Solicitation Questions and Answers (updated 3-26-2024) for
 Refurbish Elevators and Replace Controls
 Project: 437-22-101, RFP: 36C26324R0021

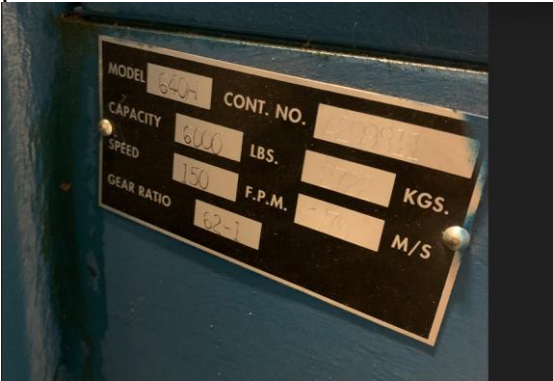
44.		Elevator #3 Please have confirm what the existing loading class as there are no marking currently.	<p>6,000lbs as indicated on the Elevator Schedule on drawing sheet A1.00. See photo below.</p>
